IN THE UNITED STATES PATENT AND TRADEMARK OFFICE

FOR: GPS POSITIONING METHOD AND GPS RECEPTION APPARATUS

LETTER SUBMITTING REPLACEMENT DRAWING SHEET(S)

OBLON, SPIVAK, et al  
Docket No: 202709US6  
Inventor: Koji HASEGAWA, et al.  
Serial No: 09/685,412  
Reply to OA dated: 11/18/03  
Replacement Sheets

FIG. 13E

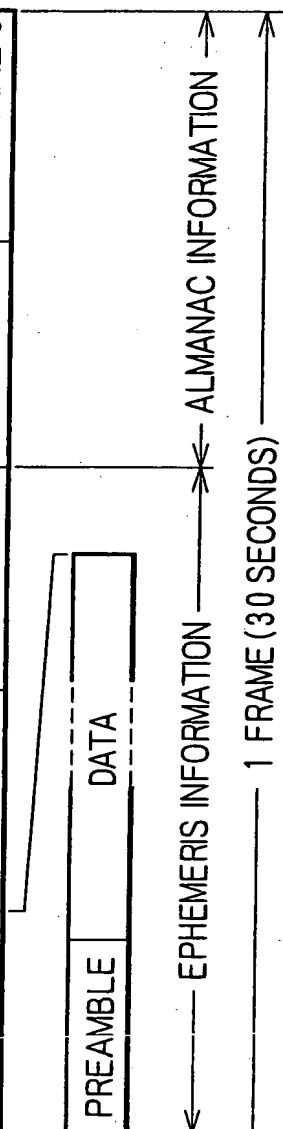
Including "Prior Art" to figures 13A-13E and 14 as required by the Examiner.
